# MEETING AGENDA

## Appearance Commission

Village of Homewood

A. **Public Meeting** for Case 24-34: Wind Creek Casino Site Signage and Sign Variance

# 20A | Primary Parking Entry/Exit

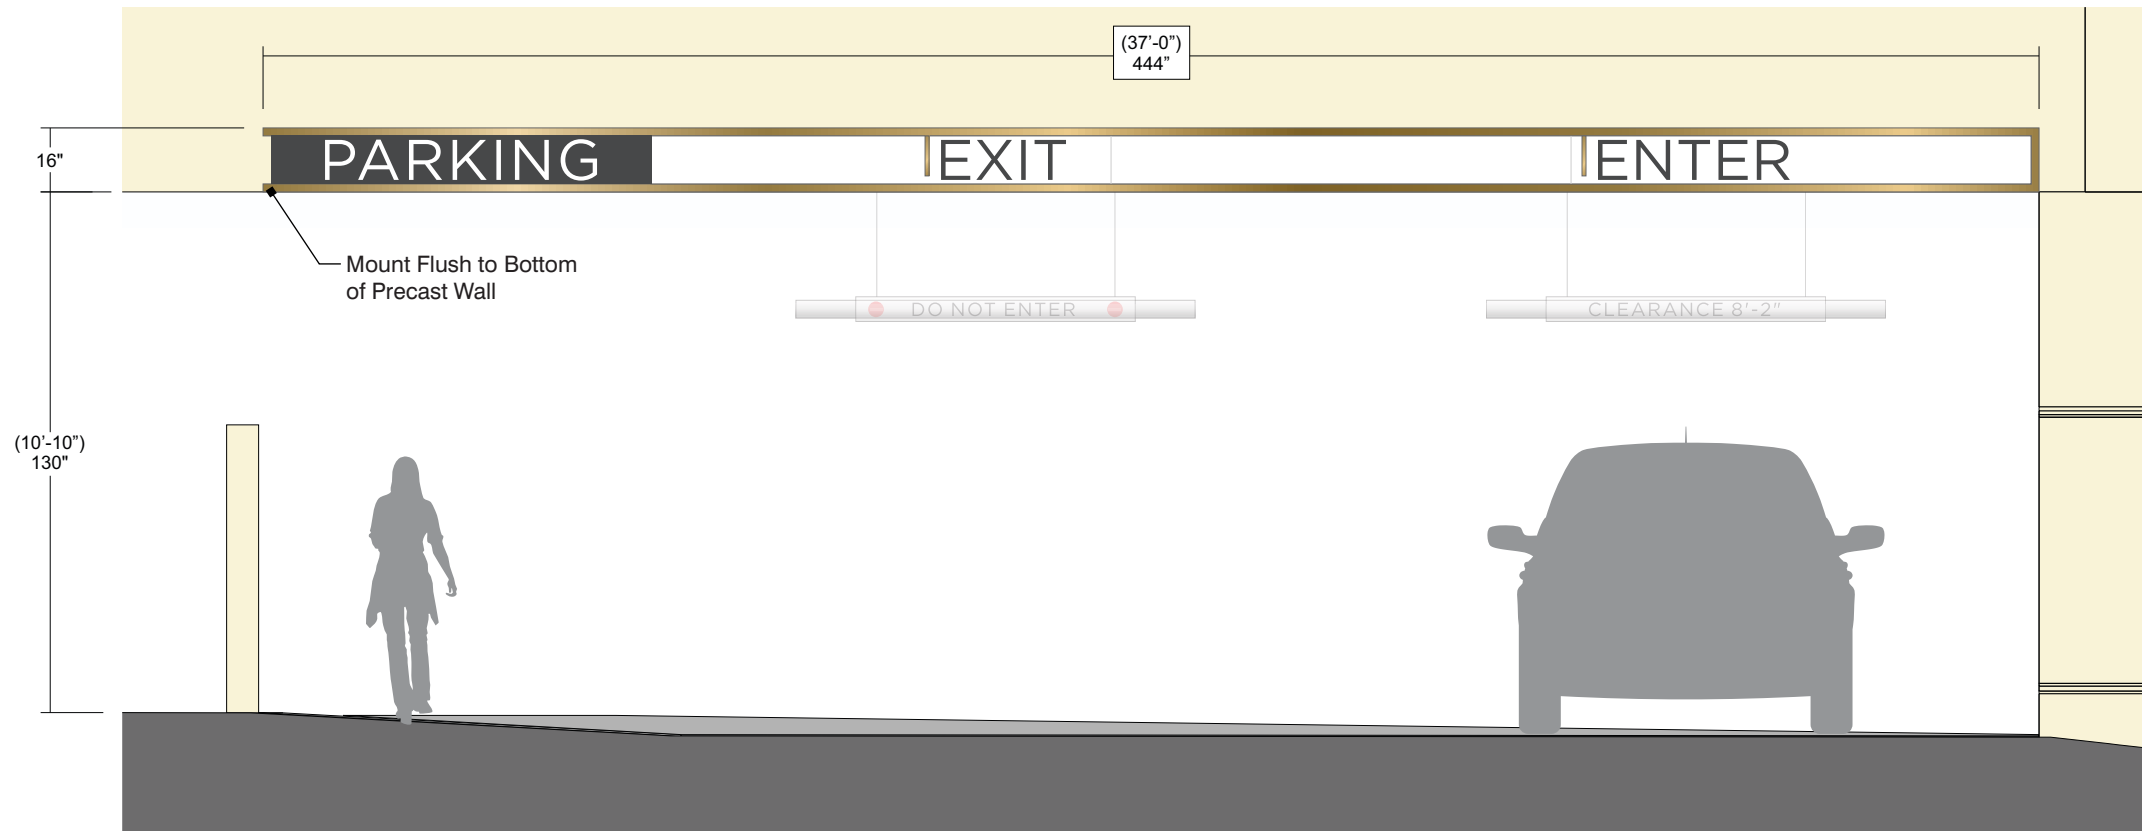
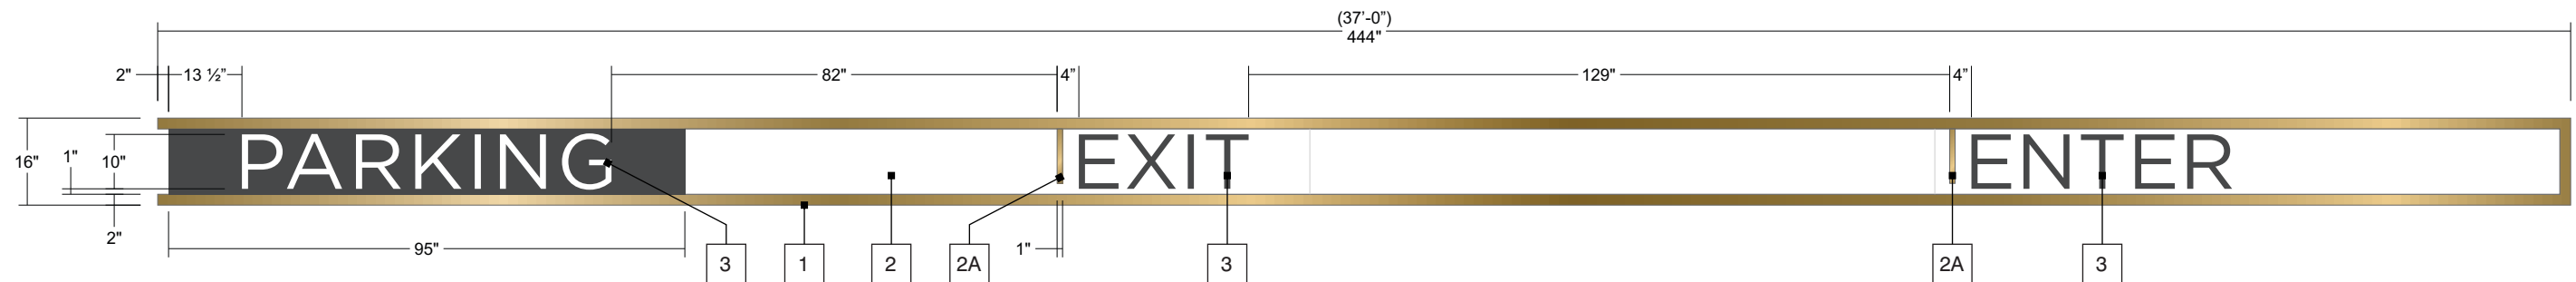
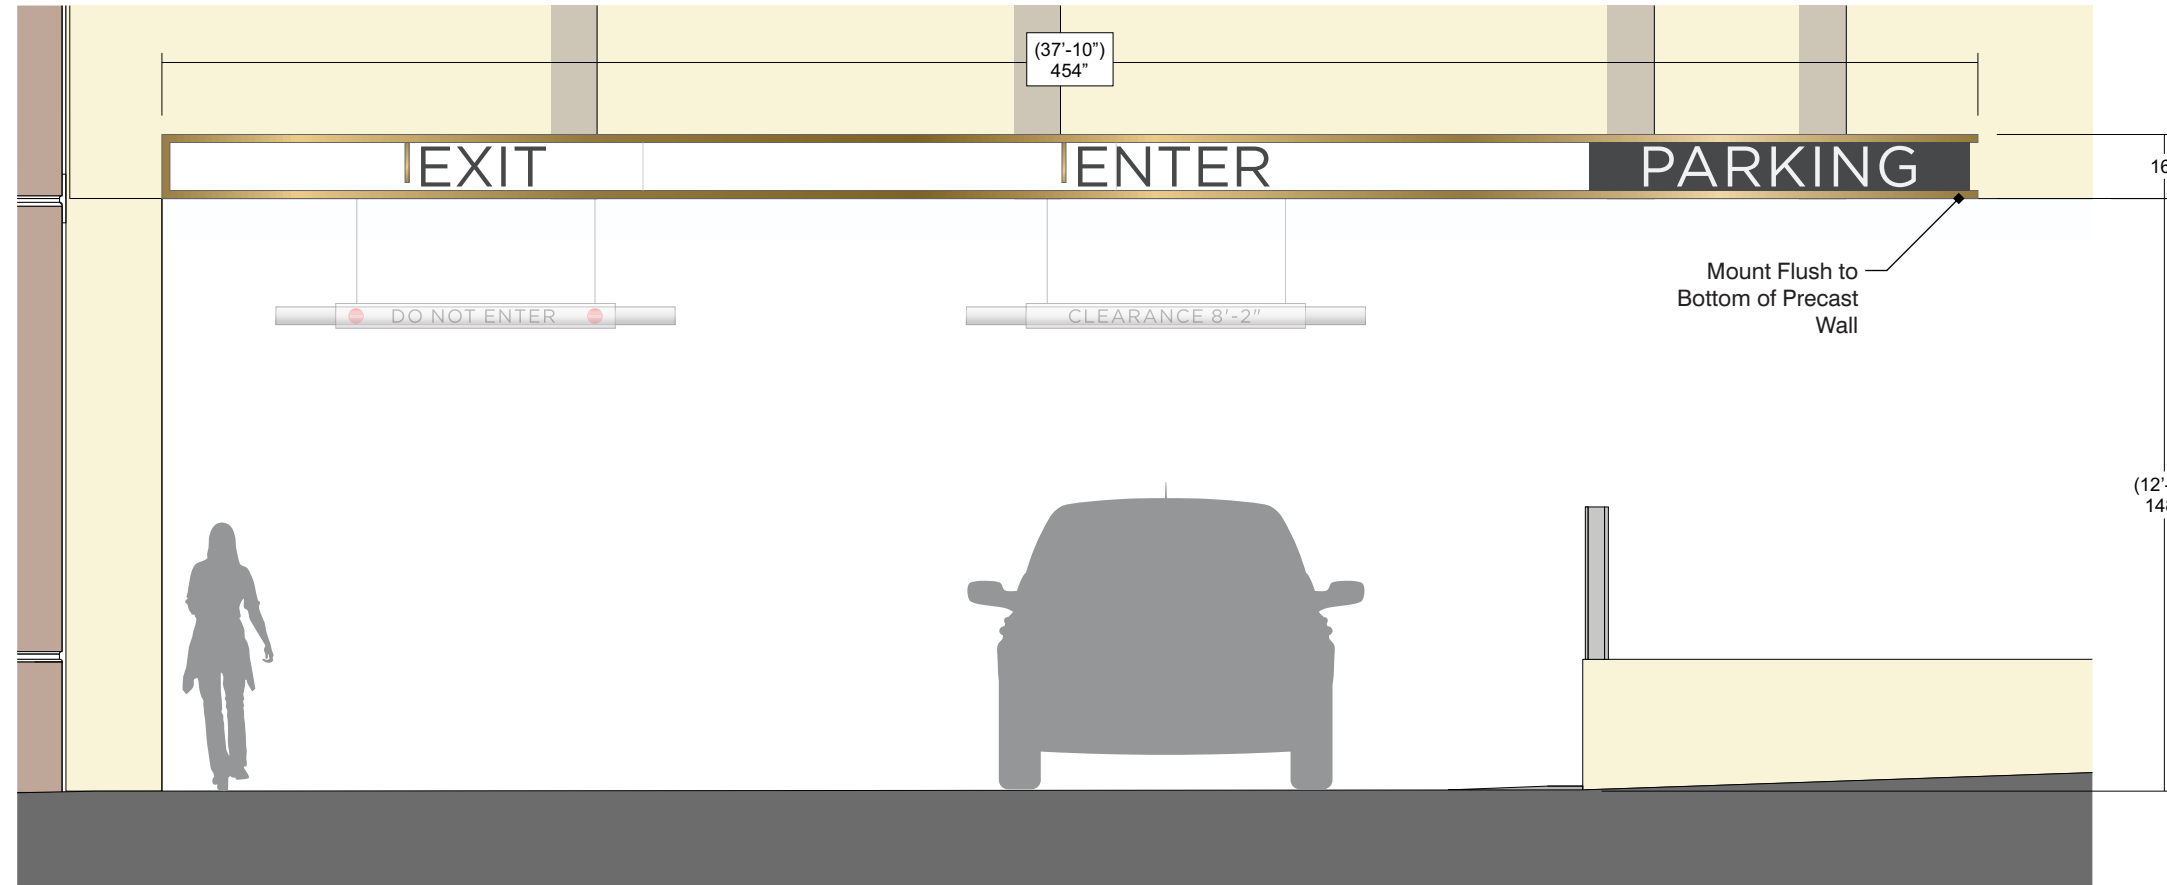
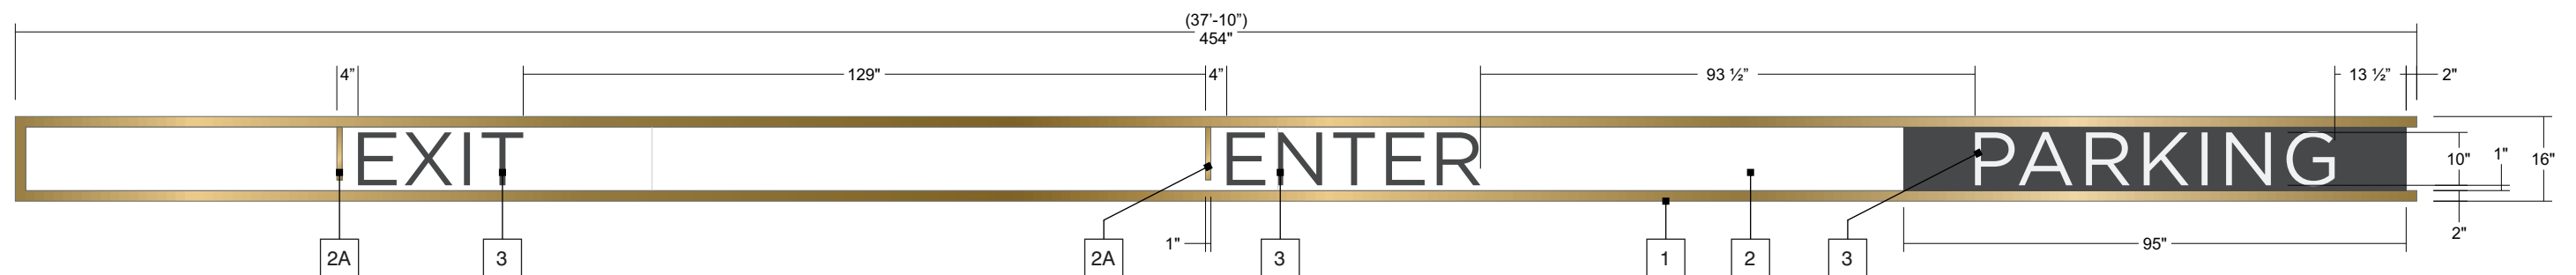
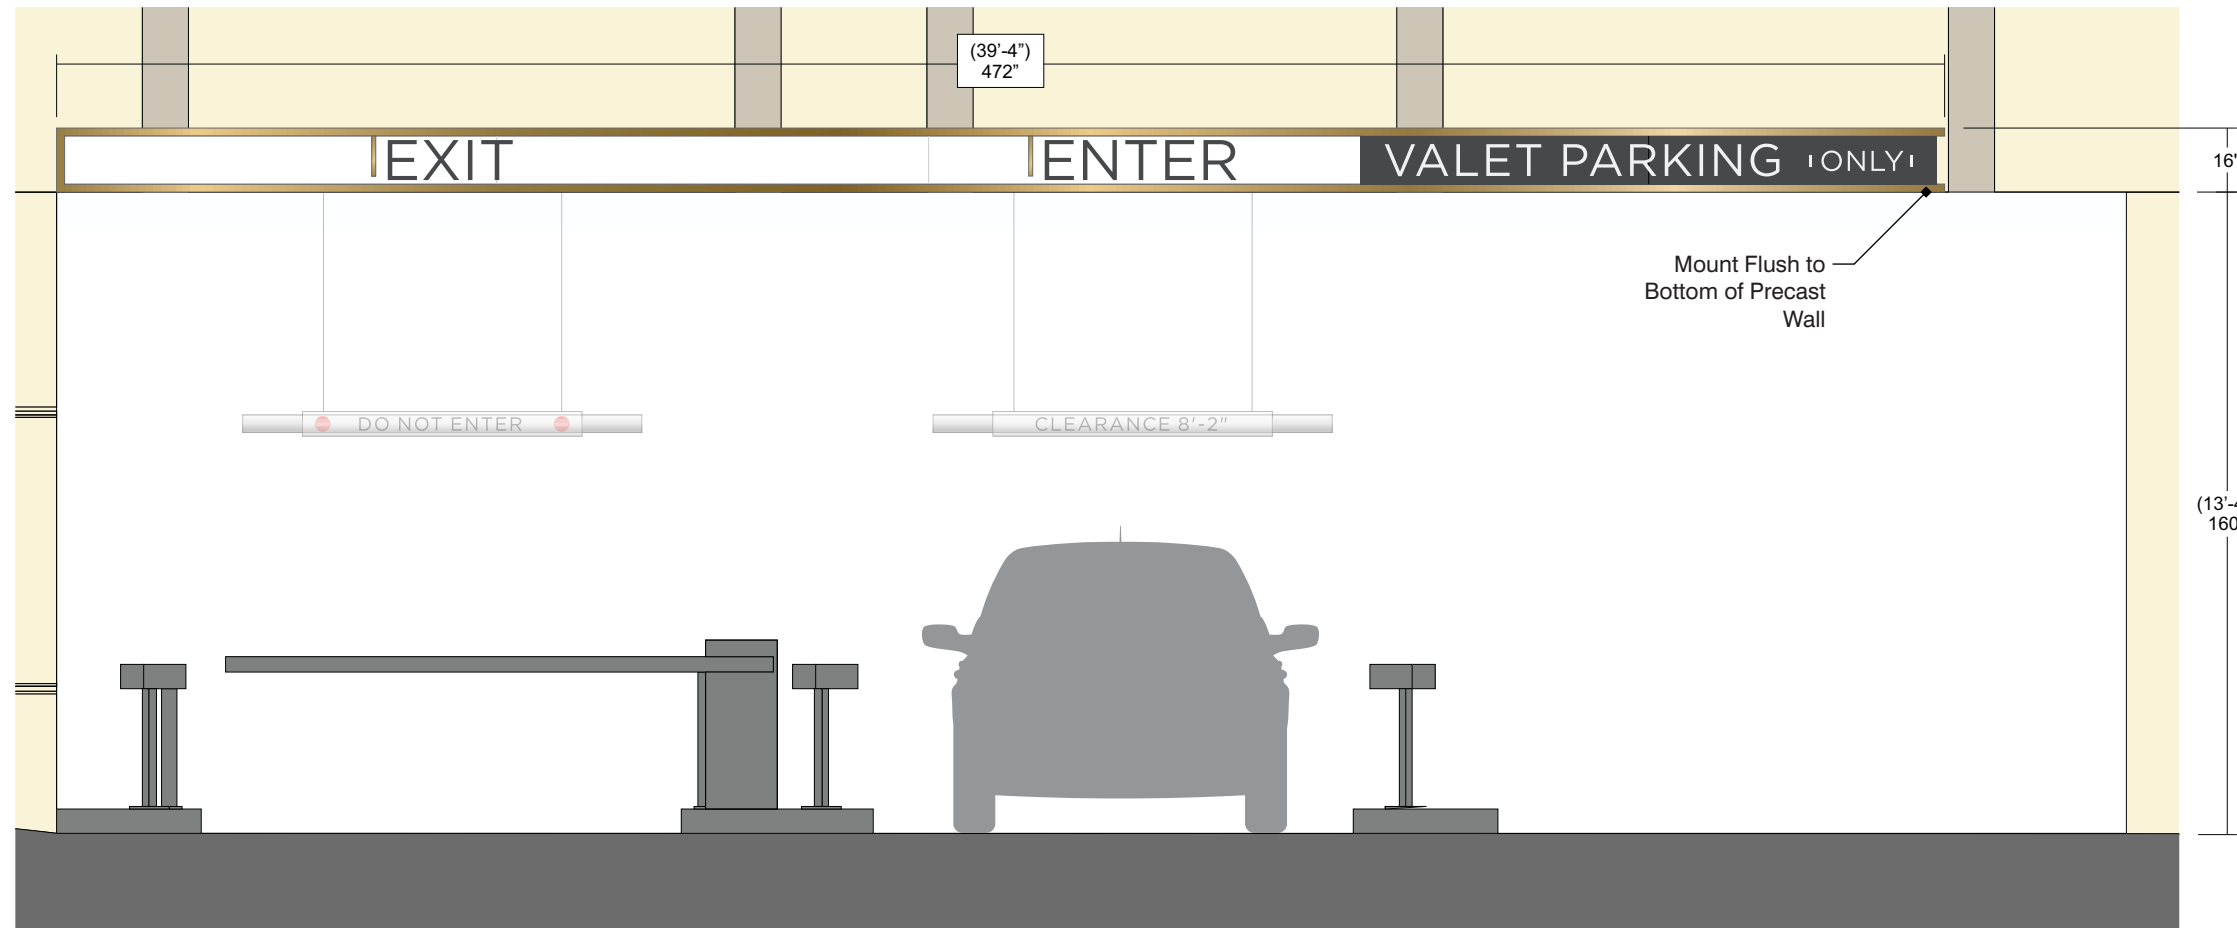
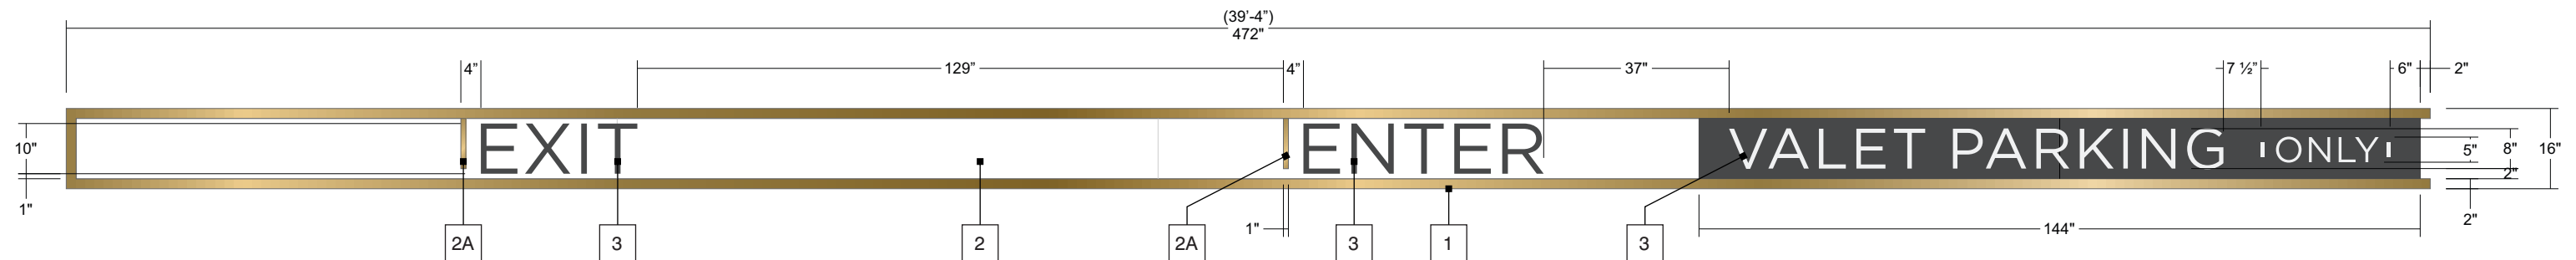
The applicant has proposed three exterior directional signs at the top of vehicular entrances at three locations in the parking garage. These signs are designed to guide motorists to entrance and exit lanes at each access point into the garage and provide required information at each access point.

Each directional sign proposed is 16 inches in height and varies from 37' to 39' 4" in length. The signs are between 49.3 to 54.4 square feet in area. The signs are rectangular aluminum tubing (1.5" x 2") with a gold color, surrounding a colored aluminum sign face with white or dark grey color. Lettering on the sign will be acrylic with white or dark grey lettering as necessary to provide contrast from the colored aluminum sign face. The signs will extend across the full span of each vehicular access point.

Directional signs under three square feet in area are exempt from sign permit review. Signs greater than three square feet must meet the requirements of Section 30 (Signs) of the Village Code of Ordinances. However, the sign code does not provide standards for directional signs greater than three square feet in area, nor are directional signs identified as a permitted sign in Section 30-4.(a) of the Village Sign Code.

Section 30-1 exempts directional signs below 3 square feet in area. Chapter 30 of the Code of Ordinances does not provide standards for directional signs larger than this size.

**LANDLORD REVIEW - M & J WILKOW**

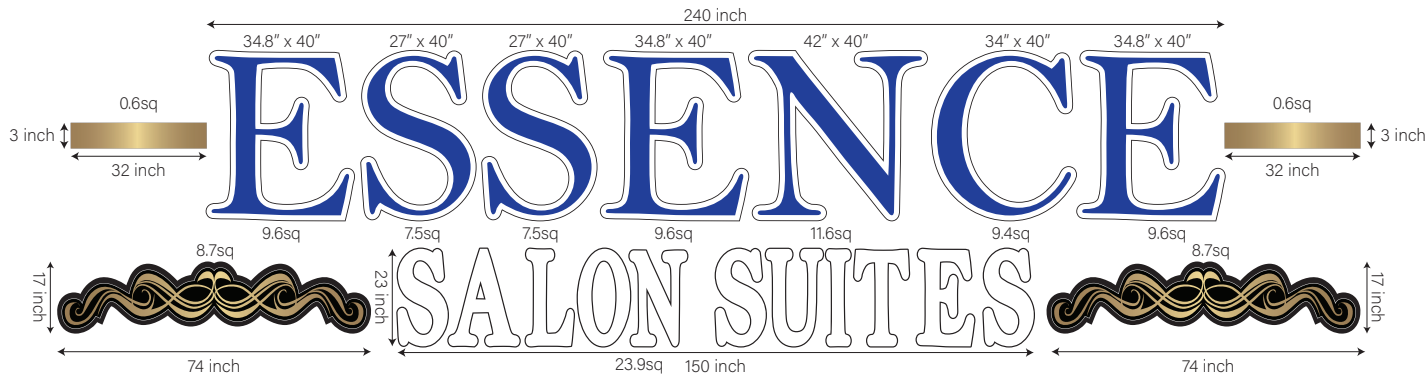
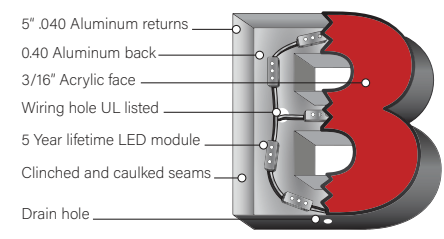
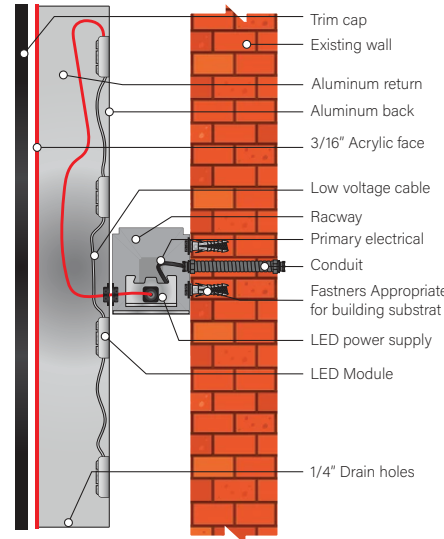
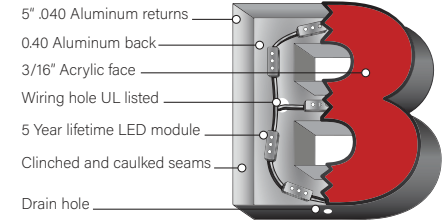
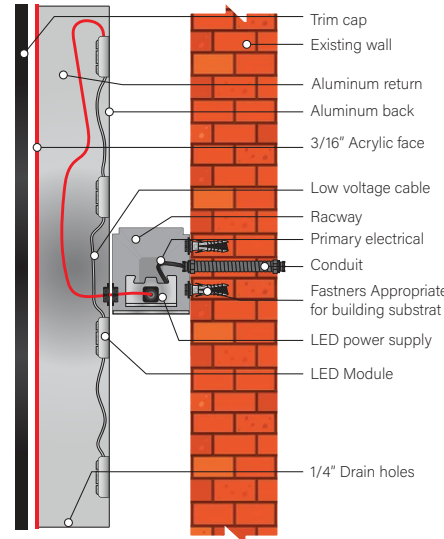
<input type="checkbox"/> APPROVED	<input type="checkbox"/> APPROVED AS NOTED
	<input checked="" type="checkbox"/> REVISE & RESUBMIT

- TYPICAL NOTES:
- NO EXPOSED HARDWARE, CONNECTORS, OR WIRING.
  - NO LIGHT LEAKS.
  - 24 HOUR/7 DAY TIMER REQUIRED- SIGN MUST BE ILLUMINATED DURING MALL HOURS.
  - SIGNBAND MUST BE REFURBISHED TO LIKE NEW CONDITION.
  - NO HOLES OR MARKS FROM PREVIOUS SIGNS ARE ALLOWED.
  - FIRST CLASS WORKMANSHIP IS REQUIRED.
  - ANY NEW OR EXISTING PENETRATIONS MUST BE MADE WATER TIGHT.
  - PROVIDE WEEP HOLES FOR ADEQUATE DRAINAGE.

SUBMIT ANY PROPOSED TEMP SIGNAGE.

RACEWAY MUST BE PAINTED TO MATCH BACKGROUND.
